P91-011

APPLICANT	B. H. Bocook, Architect, 650 Howe Avenue, Suite 1045, Sacramento, California 95825
OWNER	Spieker - French - Davenport #200, 2150 River Plaza Drive, Suite 160, Sacramento, California 95833
PLANS BY	B. H. Bocook, Architect, 650 Howe Avenue, Suite 1045, Sacramento, California 95825
FLILING DATE	January 17, 1991
ASSESSOR'S PCL. NO.	274-0320-067
	ENVIR DET Negative Declaration
	REPORT BY CG

- A. Negative Declaration
- B. Special Permit to construct a 63,662 square foot (66,840 gross square feet), three story, office building in the Gateway Center Planned Unit Development on 3.85± vacant acres in the Office Building (OB{PUD}) zone.

LOCATION: 2151 River Plaza Drive

Preliminary Landscape Plan

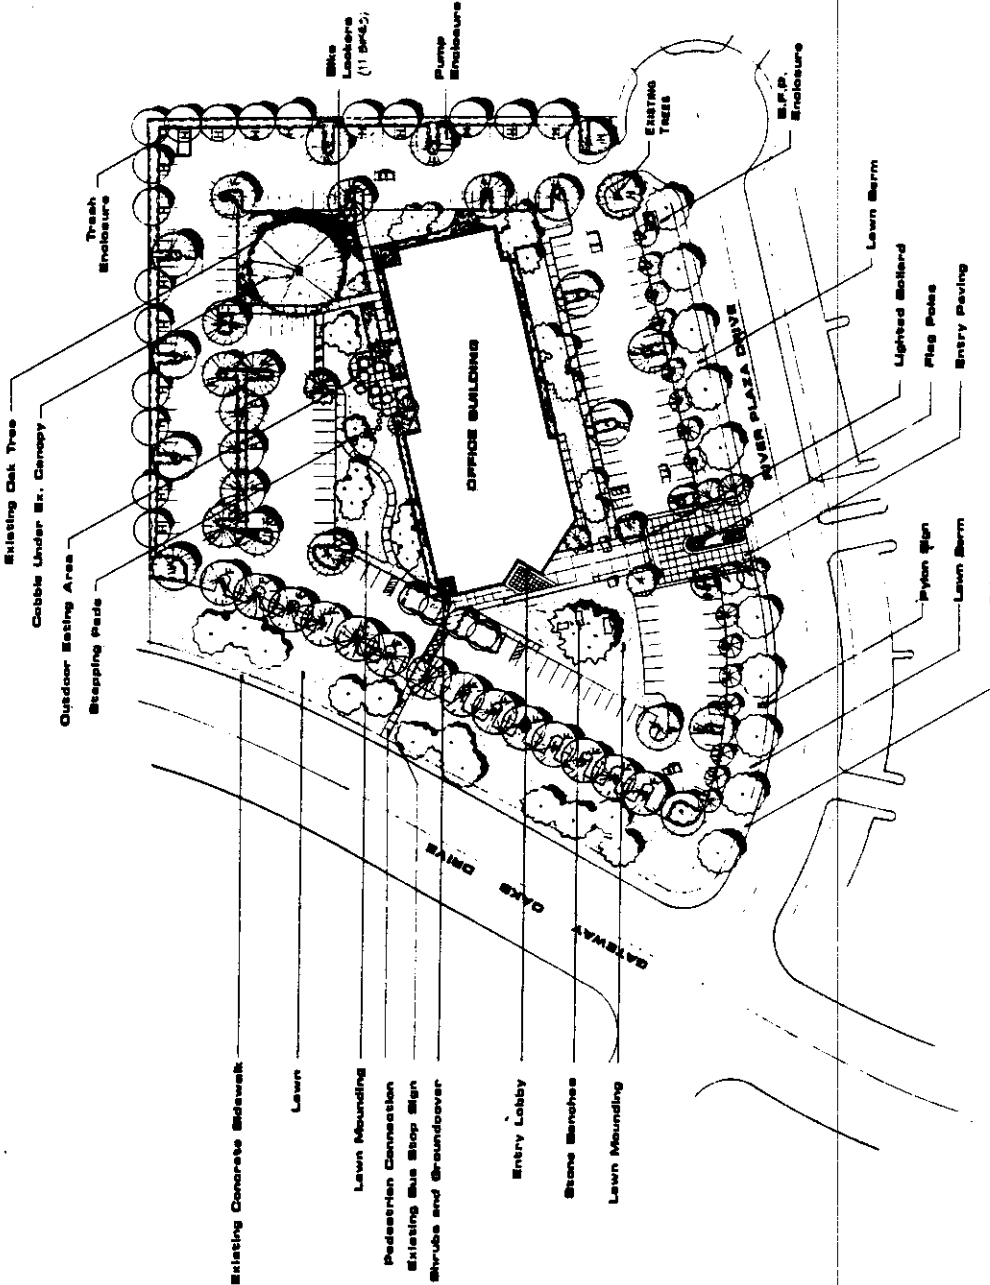
- 1. The 40 foot and 100 foot landscaped setbacks along the streets shall consist of turfed undulating berms, shrubs, and trees.

SOUTH ELEVATION

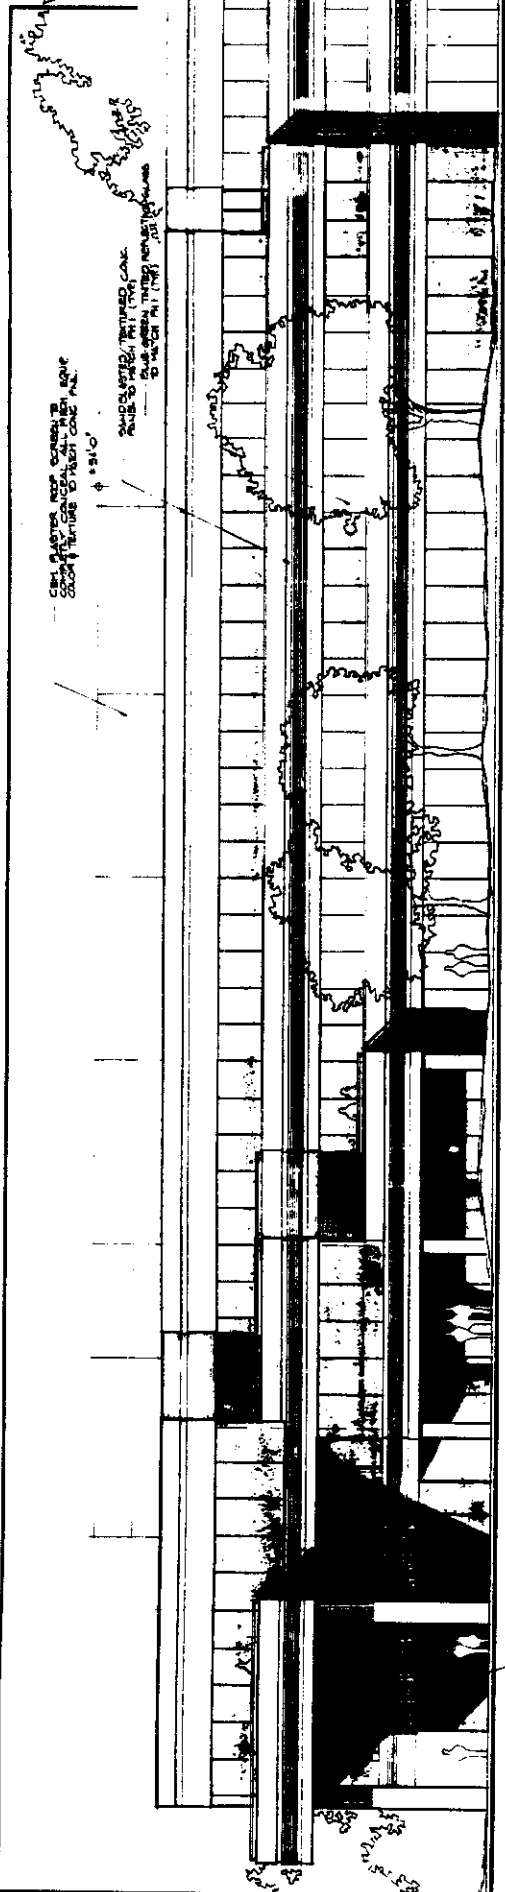
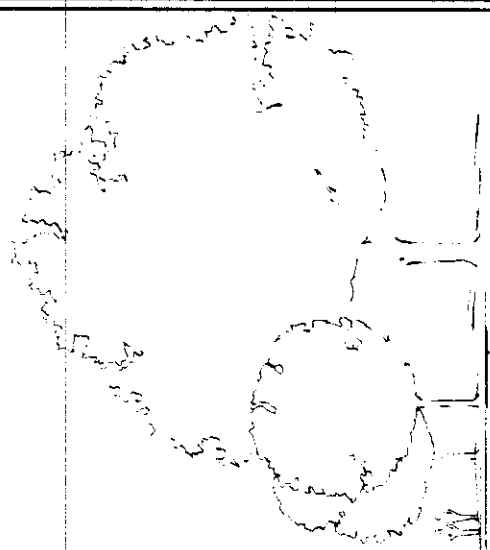
- 5. The building shall be designed as per the submitted elevations.
- 4. All roof equipment shall be screened. This screen shall have the same color and texture as the proposed building.

- D. Building Design**
- The proposed 66,840 square foot building contains three stories, 45 feet to the top of parapet. The primary building materials will be textured concrete and glass. These materials are the same as the existing Phase I office building across River Plaza Drive. The building design is also compatible with other office buildings in the area. The submitted plans also indicate a cement plaster roof screen to conceal the mechanical equipment. This screen should have the same color and texture as the proposed building.

SITE PLAN 1" = 40'-0"

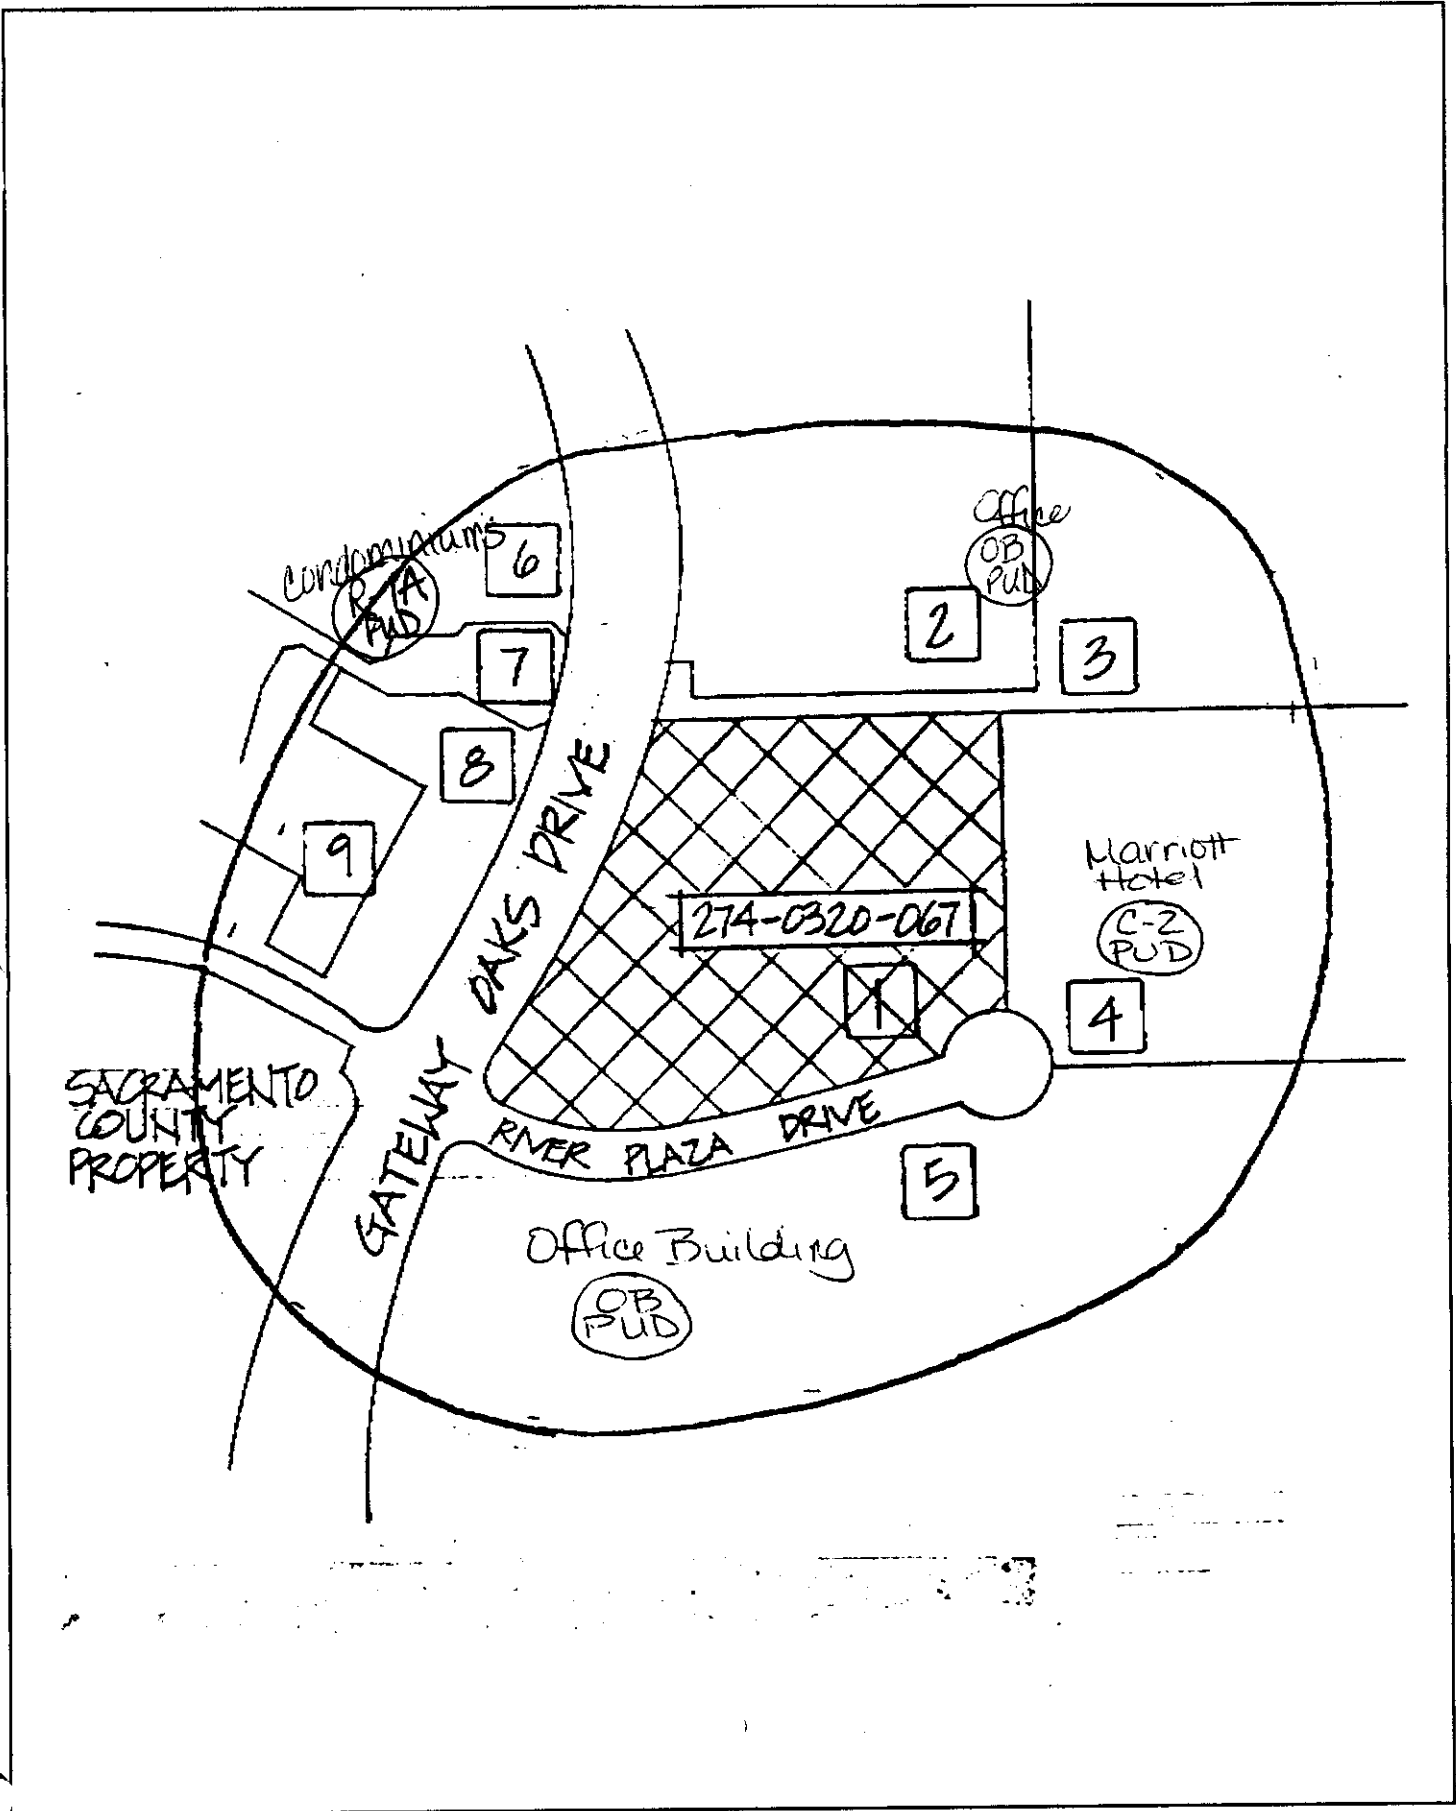
- 2. The pedestrian walkway from the building, through the parking area, and through the landscaped setback to Gateway Oaks Drive shall be provided as indicated on the submitted site plan.

require a minimum of 223 parking spaces. The property is under development agreement which only allows the reduction in parking by mutual consent of the developer and the City. The existing parking ratio of one space per 250 square feet would require 267 spaces. The site plan indicates 251 parking spaces which is a ratio of one space per 265 gross square feet. This is within the range allowed in Planned Unit Developments.

- C. Site Plan Design**
- The site plan has been designed such that the 66,840 square foot office building is located in the center of the subject site with parking surrounding it. The applicant has provided a 40 foot landscaped setback and a 100 foot building setback from Gateway Oaks Drive. River Plaza Drive contains a 25 foot landscaped setback and approximately a 100 foot building setback. These landscaped areas should consist of turfed undulating berms, shrubs and trees. The interior property lines have 7 feet of landscaped area. The site plan also incorporates a pedestrian walkway from the building, through the parking area, and through the landscaped setback to Gateway Oaks Drive. The allows pedestrians to easily walk from the office building to the existing transit stop on Gateway Oaks Drive. The site plan also incorporates landscaped areas adjacent to the office building which will provide places for employee amenities. These landscaped areas also surround existing oak trees on the site.

- The applicant has located the trash enclosure towards the northeast corner of the subject site. The enclosure should meet all the requirements of the Zoning Ordinance. This includes perimeter landscaping and a man door. The enclosure block wall shall have a textured coating to match the proposed office building materials as indicated on the submitted plans. The required metal gates shall be painted to match the building.
